**TOWN OF MOUNTAIN VILLAGE  
SPECIAL DESIGN REVIEW BOARD MEETING  
TUESDAY, MAY 31, 2022 10:00AM  
MOUNTAIN VILLAGE TOWN HALL  
455 MOUNTAIN VILLAGE BLVD, MOUNTAIN VILLAGE, COLORADO  
TO BE HELD HYBRID THROUGH ZOOM:**

**RE:** Staff Memo – Review and Recommendation to Town Council Regarding a Major Planned Unit Development Amendment to the Lot 109R Planned Unit Development, commonly called the Mountain Village Hotel PUD, by Tiara Telluride, LLC.

**APPLICATION OVERVIEW: Mixed Use Development inclusive of a hotel, condominiums, lodge units and employee housing on Lot 109R**

**FLOOR PLAN - TRASH & SNOWMELT BOILER SYSTEM ENCLOSURE**  
1/8" = 1'-0"

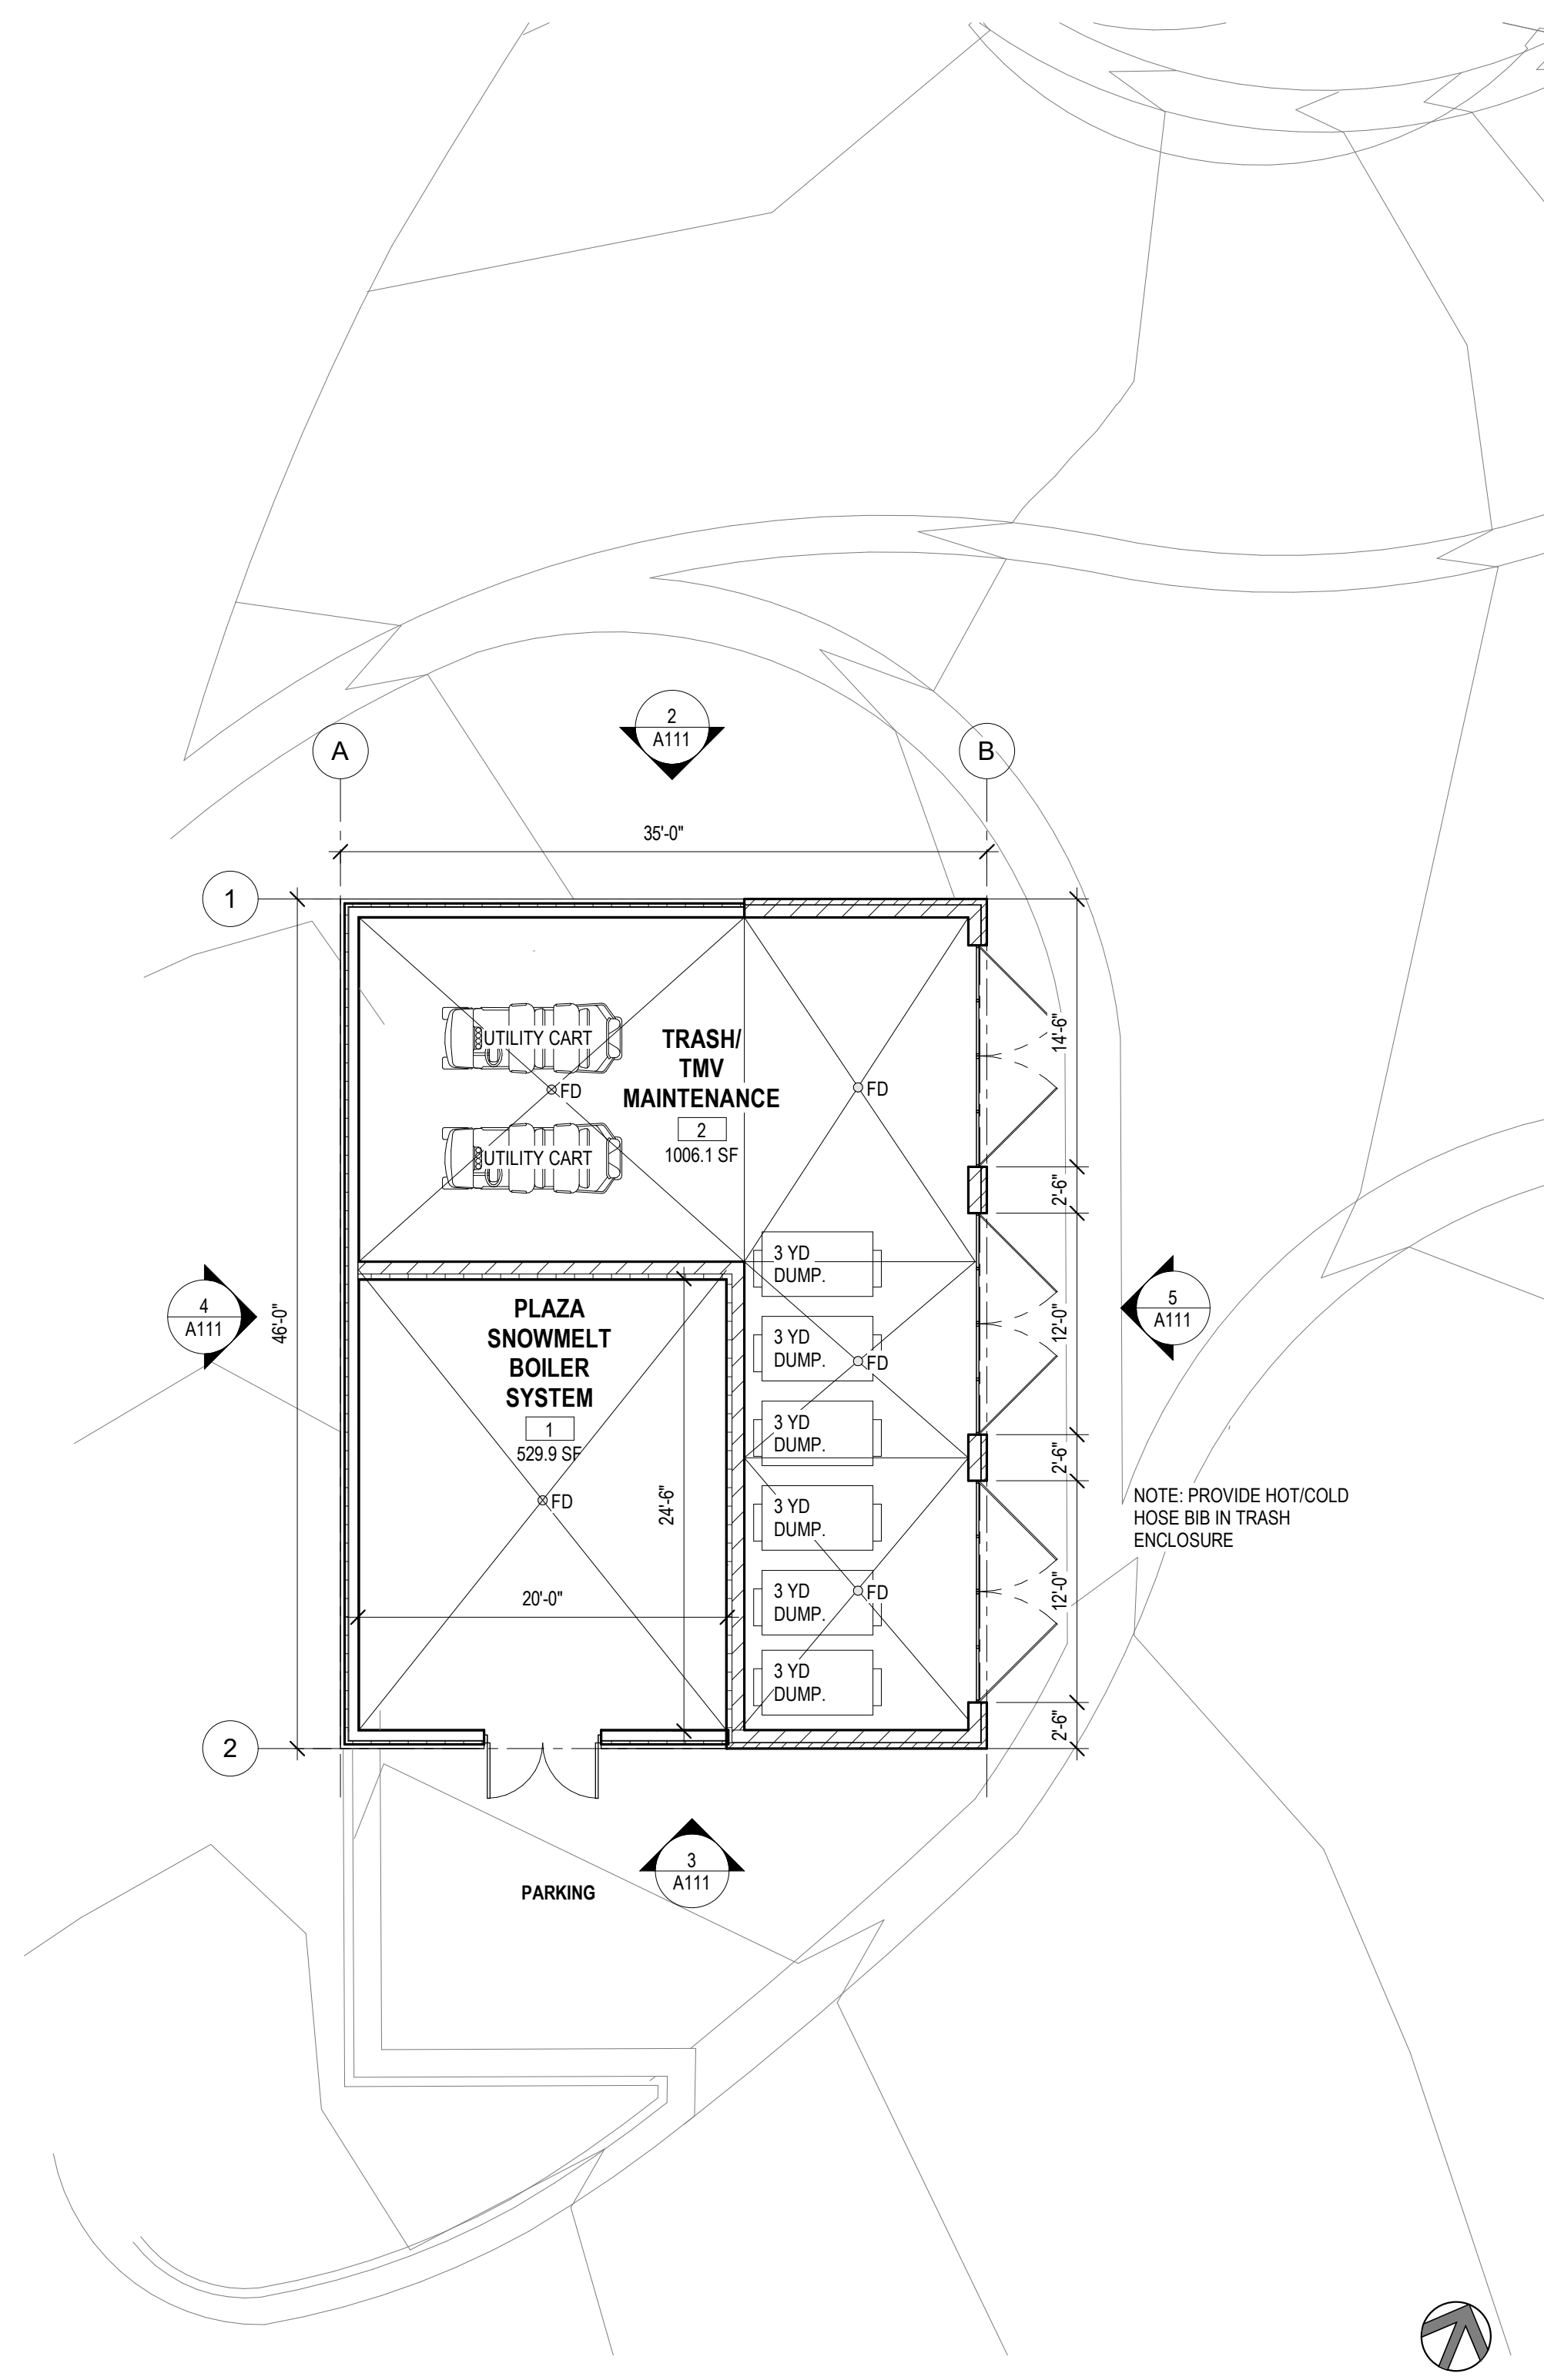
*The proposed Town trash building is also inclusive of boilers for the snowmelt system that serves the plazas and sidewalks. Due to this boiler location the fire marshal indicated the trash building will need to be fire sprinkled. With the revised plan staff's comments include that we do not want to lose any square footage over the existing square footage the town utilizes in the existing town building. The applicants will need to make the building larger to match our existing space, by increasing the square footage of the building. The applicant has also indicated that it would be necessary for an additional boiler room on the southeast corner under the public access stairs. As proposed, this would be located on Town open space. Staff does not support the location of an additional boiler room in this location and doesn't believe that additional boiler space outside of that already proposed in the trash building would be necessary for the amount of snowmelt currently indicated on the snowmelt plans. Staff asks that the snowmelt plan be revised to include the remaining area south of the trash shed used for parking and access to the boiler room and the sidewalk from Shirana to Mountain Village Boulevard, the additional boiler room be removed from town open space and the trash shed expand in size so that the town maintains the same square footage as utilized today. See referral comments.*

*The elevations provided do not show an exhaust for the boilers and this could have a marked visual impact on neighbors. This will be important to understand as it will have visual impact on the neighboring buildings. More detail needs to be provided in terms of materials and material percentages. Staff also has concerns about the gate openings to the dumpster area and needed clearances for the gates to open. It seems that overhead doors might be more appropriate given the congested condition of this multi-use area. Referral comments from the existing operator Bruin also support the preference for overhead doors. The trash enclosure will be required to be sprinkled if a boiler room is included in the structure.*

**RESPONSE: Refer to revised trash facility plan sheet A-111. This will be conditional upon additional boiler space granted in other areas. Boilers and venting to be provided at final submittal.**

AVERAGE HEIGHT PLAN

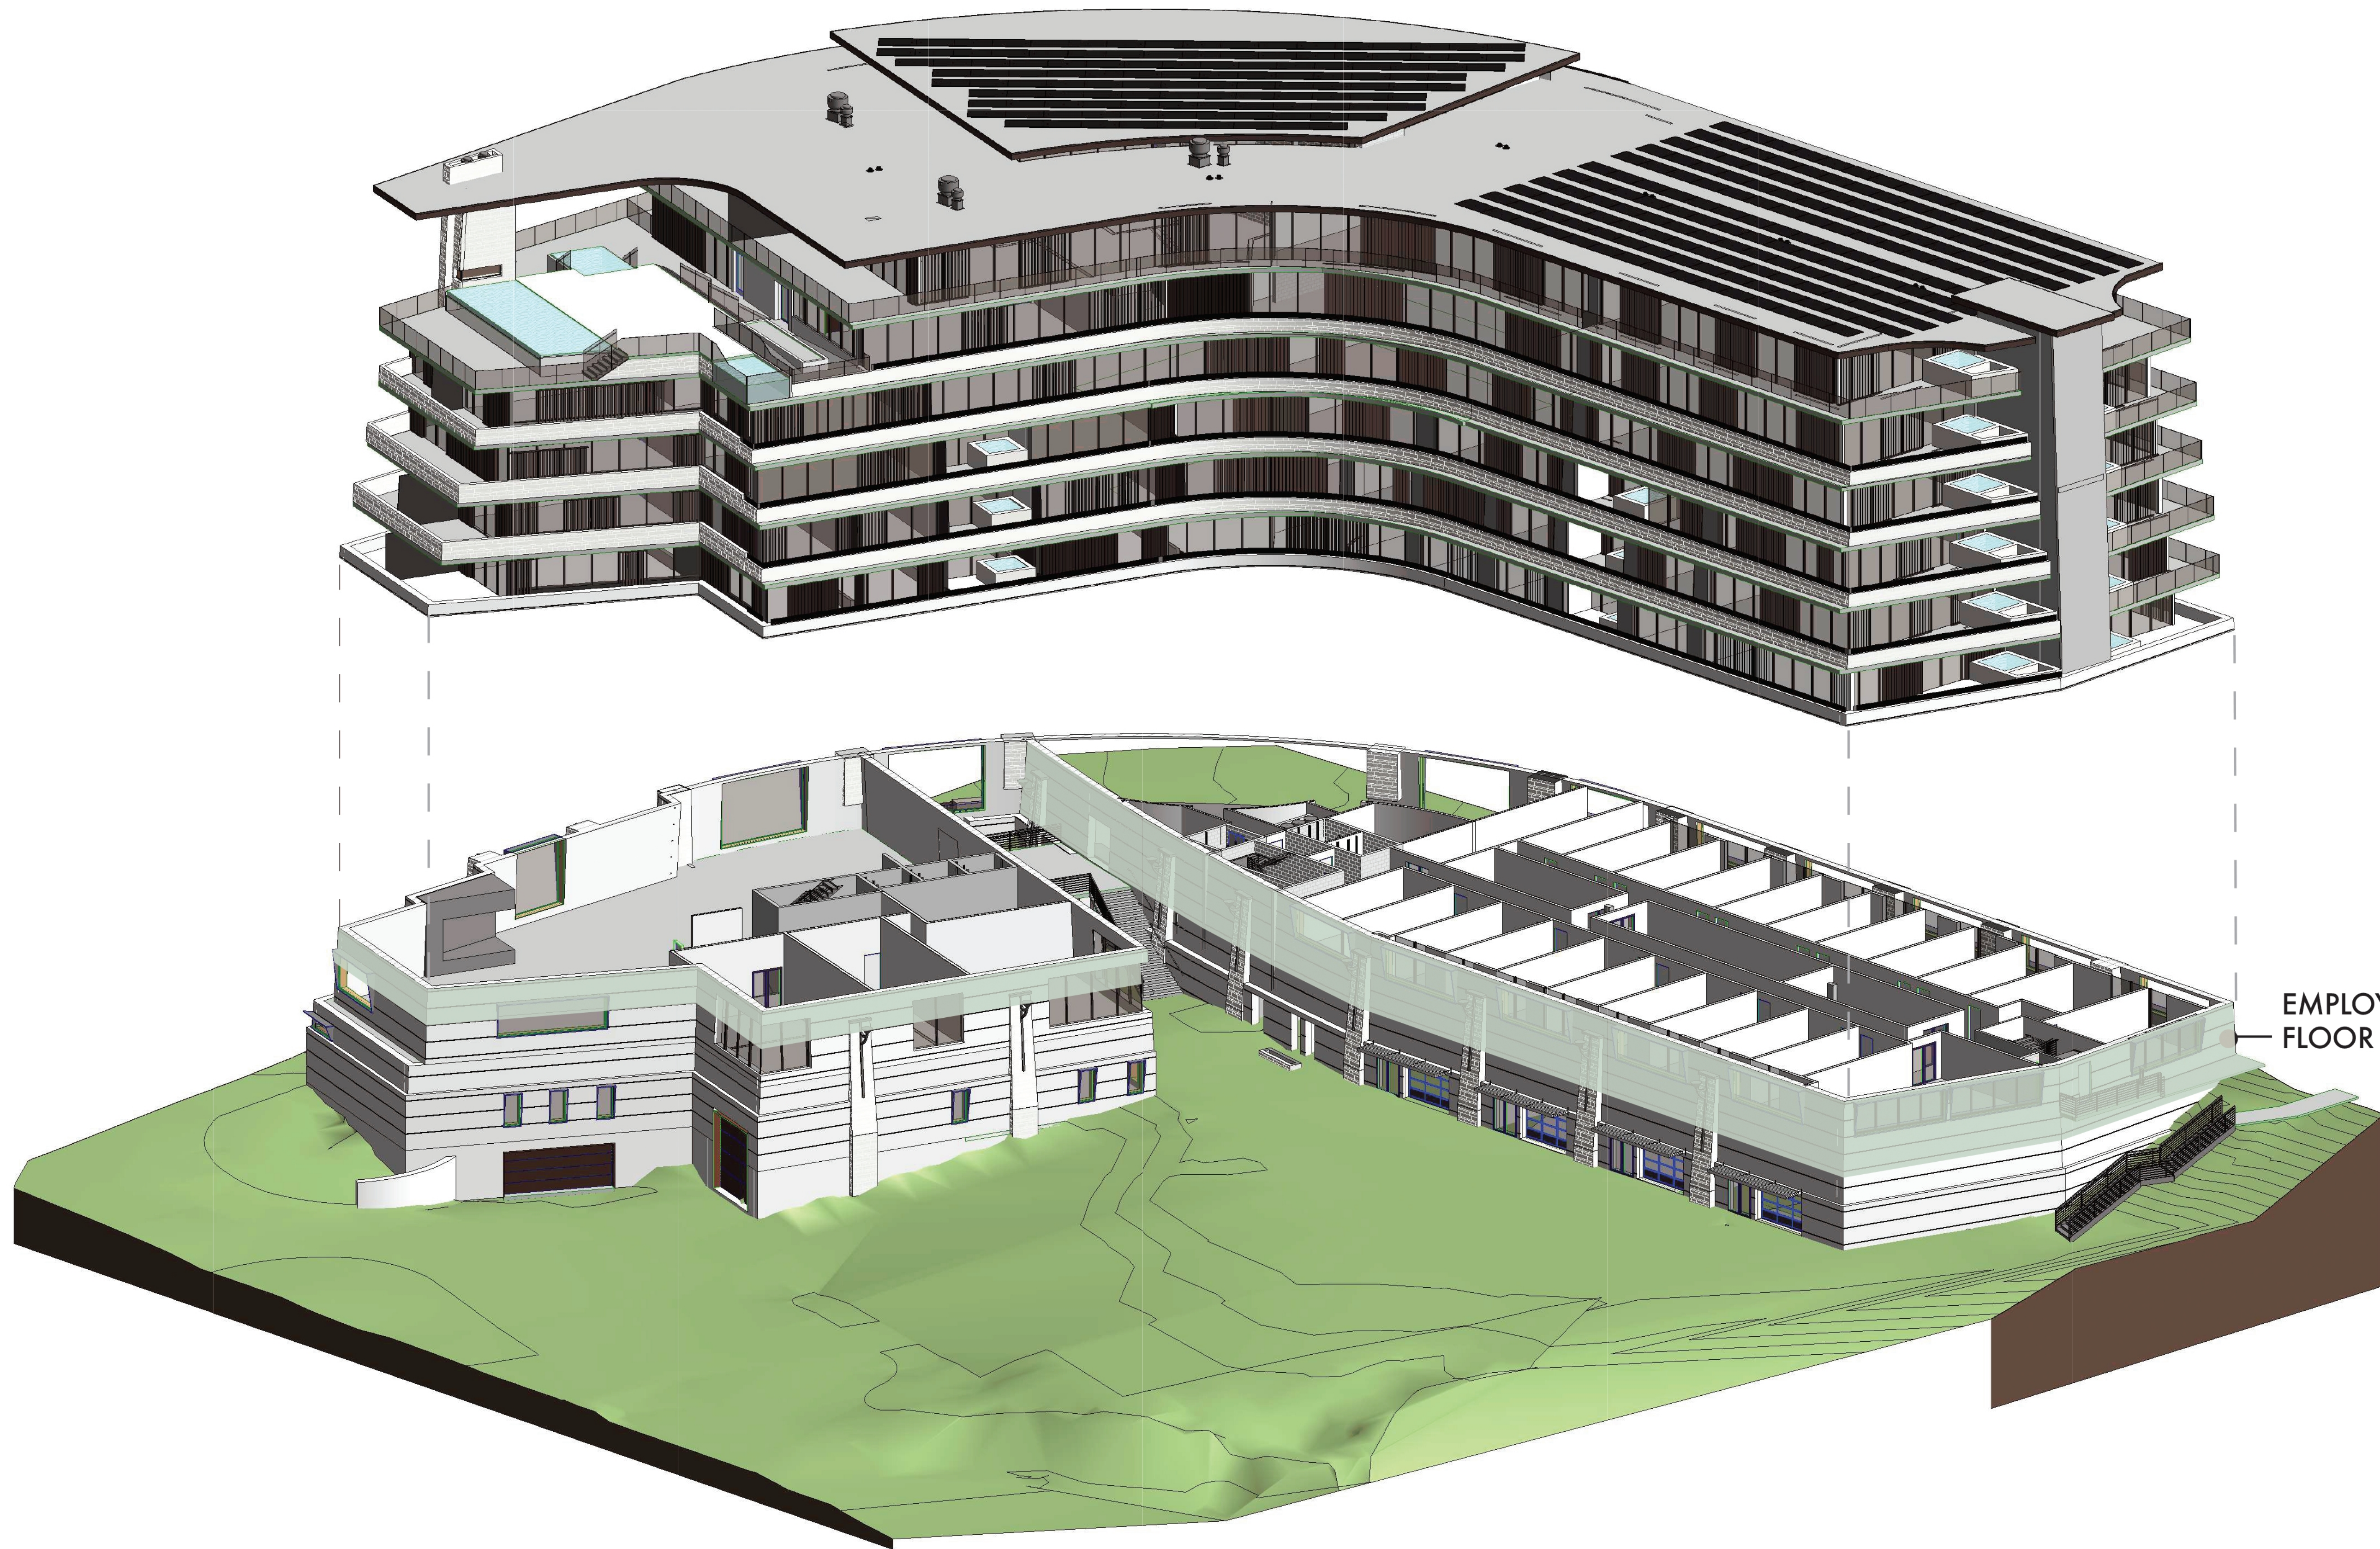
*Staff: Lot 109R has existing entitlements under the previously approved PUD agreement and design plans. This PUD granted a maximum height of 88' 9" and an average height of 65' 2.9" for the specific design package approved by the town. The current proposal shows a max height of 94.7' and an average height of 79.72'. The applicant is requesting a maximum increase in heights from 88'-9" to 96'8" with a current maximum height shown as 94'7" and an average height request increase from 65'-2.9" to 82.46' and currently shown as 79.72'. The increase in heights above the original PUD are considerations weighed against public benefits being offered and within the purview of Town Council.*

*Overall, staff believes that the applicant is now generally representing heights as prescribed per the CDC. There are three points on the NE corner of the building (A, UU and TT) shown for average heights that staff needs more clarity on why they were included in the table. These points appear to be on decks, not roof forms, but aren't shown on the elevation views, therefore staff needs more clarity from the applicant as to why these points should be included in average heights.*

**RESPONSE: Revisions have been incorporated into elevations and topos please see revised sheets A-1.12, A-2.01, A-2.02, A-2.03 and A-2.04.**
